Meeting Agenda

Zoning Board of Appeals
Wednesday, August 14, 2024
5:30 PM

- 2. ZBA 2024-006: Design Review** for Approval of a **640 SF Accessory Structure** at Mary's Market located at **4866 Bluestem Road** (PIN: 04-29-426-010).
[Property Owner: DJ Properties LLC, David Koch]
- 3. ZBA 2024-007: Design Review** for Approval of a **5,310 SF Three Family Residential Structure** located at **5729, 5731, 5733 Willow Creek** (PIN: 04-28-426-004).
[Property Owner: Willow Creek Development LLC]

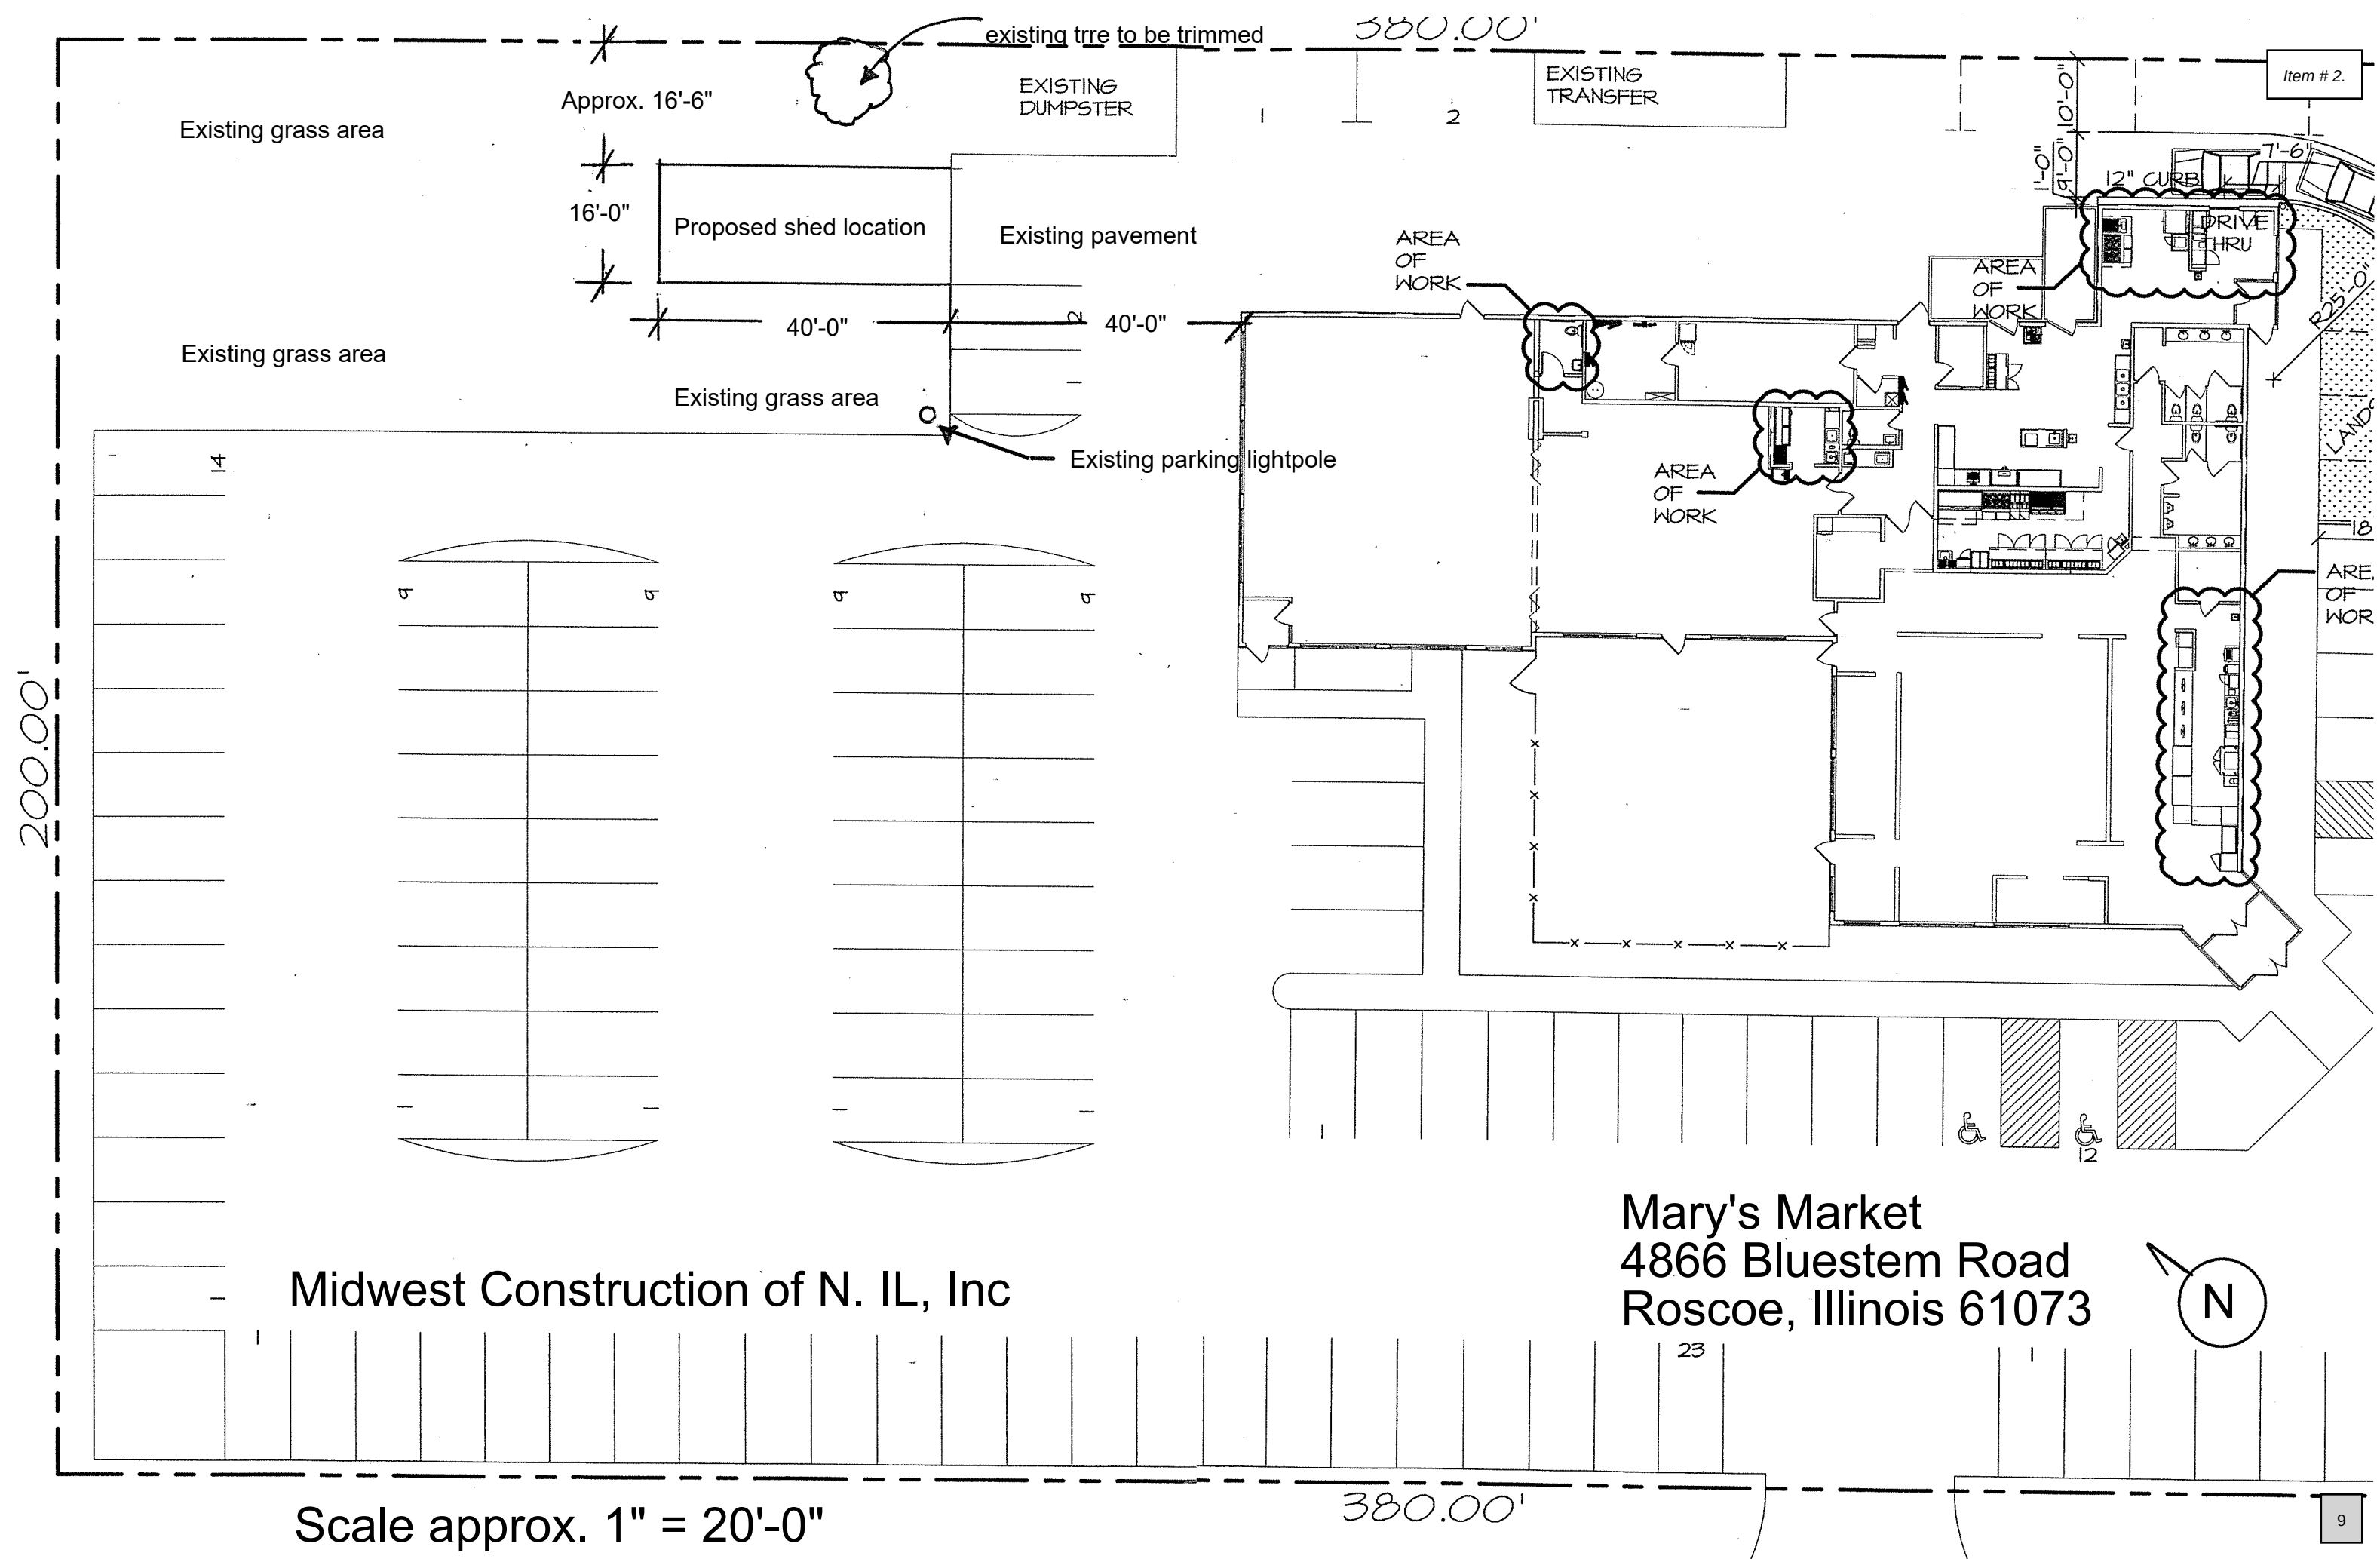
Some items/questions to note are:

1. Dimensions should be included on the drawings identifying setbacks and any easements.
[Setback to Side Lot Line = 10ft min Setback to Rear Lot Line = 10ft.]
See attached site plan – Only one set back line to be concerned with is a 10'-0" rear set back and the shed will be approx. 16'6" away from that lot line.

4. We need to see that the "Commercial structures shall be separated from parking areas through the use of landscaping and/or walkways."
See attached site plan
This shed will be approx. 40'-0" from the existing building.
This shed will be placed on and a nice level "stone" pad and the shed has its own heavy duty wood floor with 4"x 6" runners.
This shed will be set within an existing "grass" landscape area which all surrounding landscaping will remain "grass" with no additional improvements.
This shed will be set near the existing dumpster enclosure and is not blocked by any existing parking spaces.

5. Will there be lighting on or around the building.
See attached site plan – No additional exterior lighting will be required since there is a parking lot light pole just to the "right" of the shed.

9. Will this have an effect on or impede the flow of water or drainage in that location. Where is the current flow of water at that location.

This structure will be place just off of the existing pavement in an existing “grass” area.

This structure does not impede nor redirect the flow of any storm water.

**I consulted RK Johnson and Associates and from the documents “plats” that we had access to it didn’t seem the shed was going to be placed in any existing easement.
(The Village of Roscoe my want to do a little research as well.)**
